INSURV SAFETY CONCERNS

INSURV SAFETY CONCERNS

AFFF SOPV

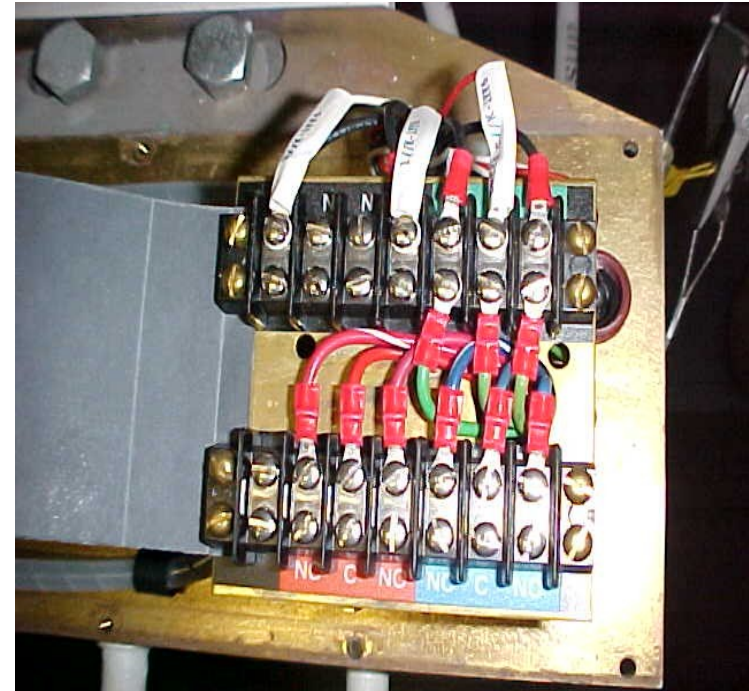
- **AFFF SOPV are not wired for burn out protection.**
- **Wiring prints conflict (NAVSEA & MFR)**
- **Ship's Force do not have clear direction to wire SOPV correctly.**

INSURV SAFETY CONCERNS **SCBA FACE PIECES**

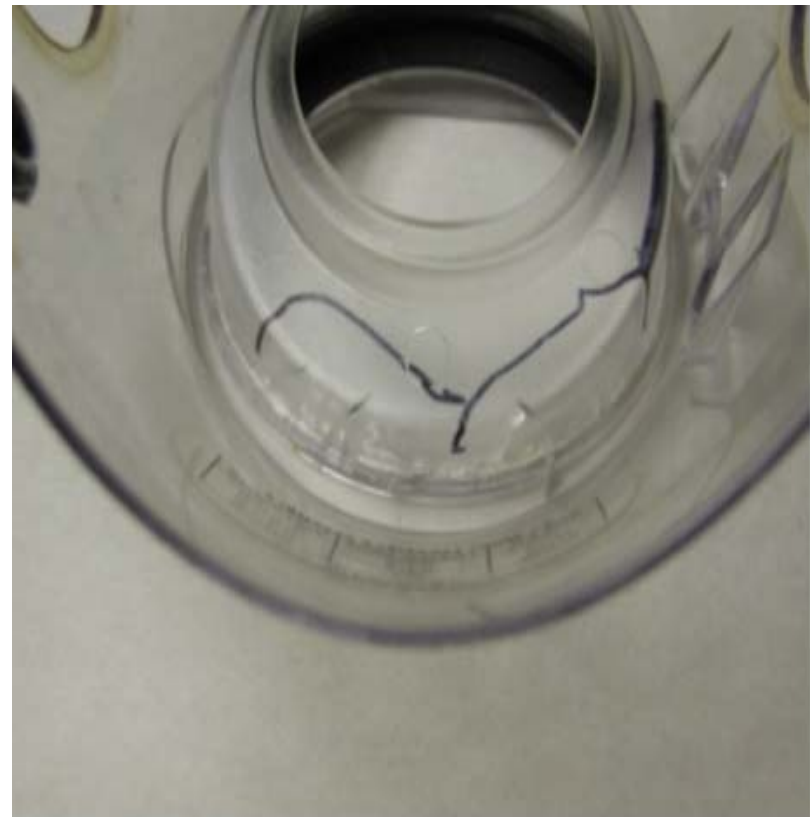
- **SCBA face pieces are cracked.**
- **S/F is not identifying cracks in the SCBA face pieces.**

INSURV SAFETY CONCERNS LPU-28 LIFE PRESERVER (SURFACE SAR SWIMMER VEST)

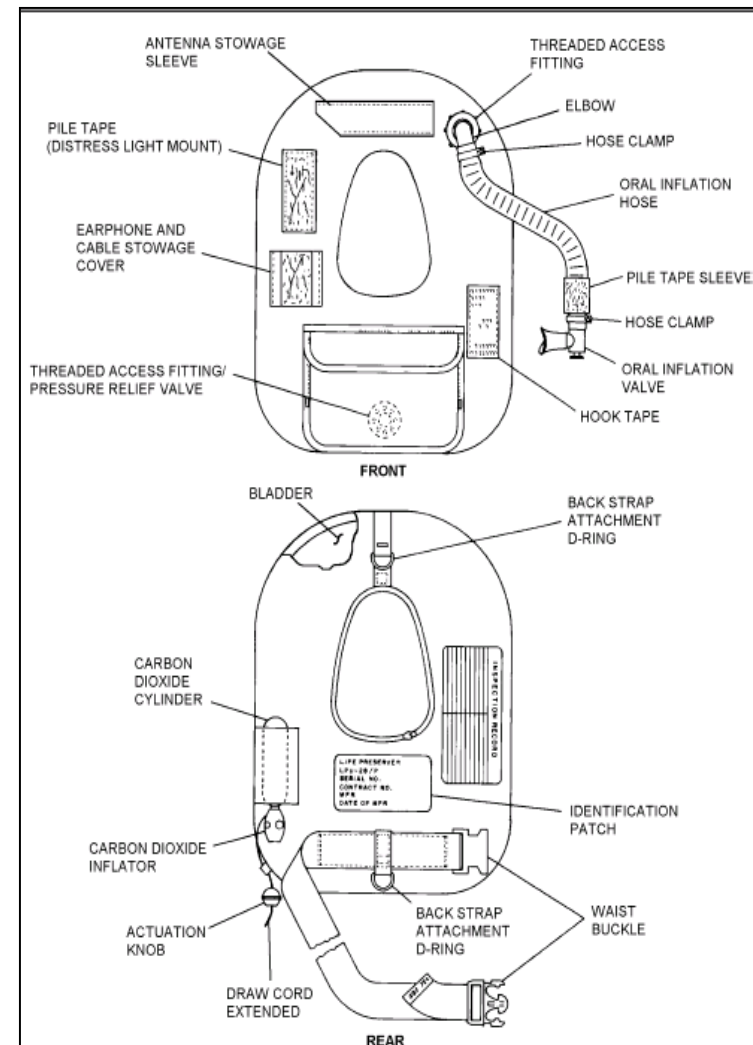
- **Maintenance not being performed or recorded IAW NAVAIR 13-1-6.1-2.**

INSURV SAFETY CONCERNS MK1 LIFE PRESERVER

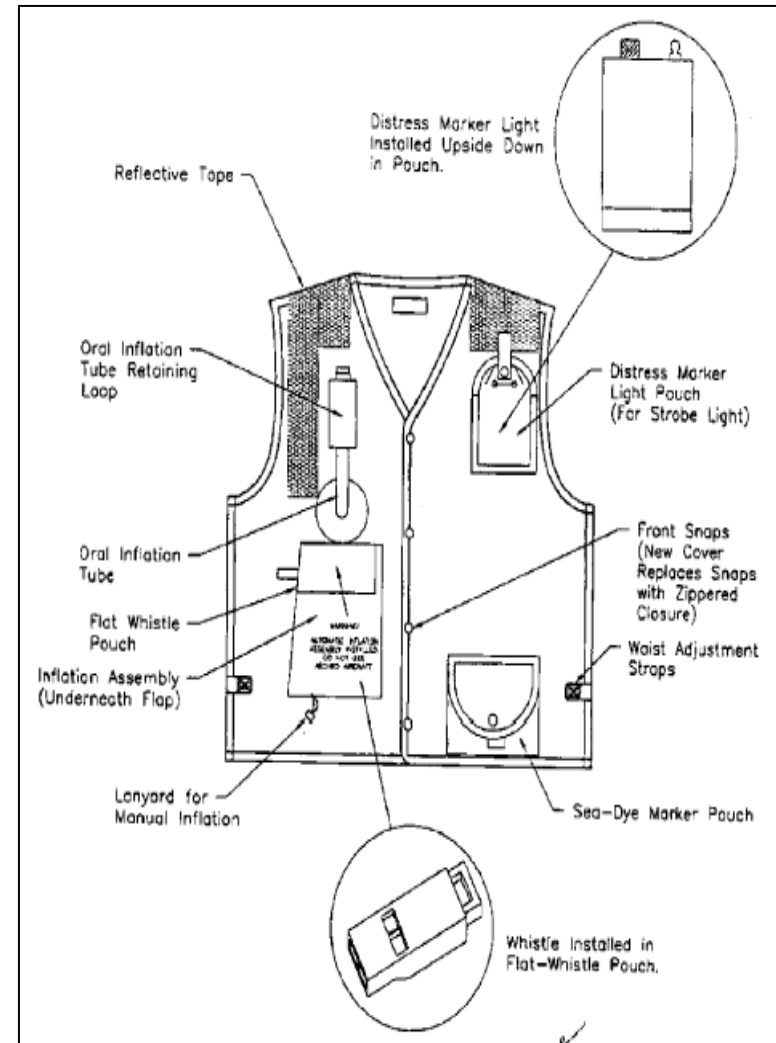
- **Sea Dye Markers not installed.**
- **Defective C02 cylinders installed.**

SINGLE AND MULTI-TANK DISHWASHERS

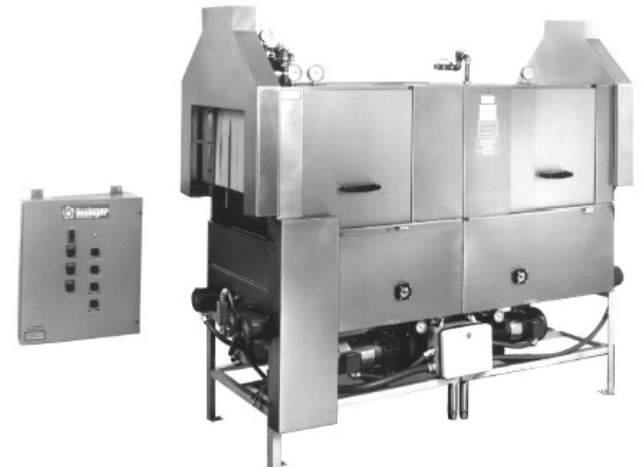
- Final rinse temps are not reaching the minimum requirement of 180 F.
- Improper sanitation & cleanliness can lead to illness of crew members at temperatures below 180 F.
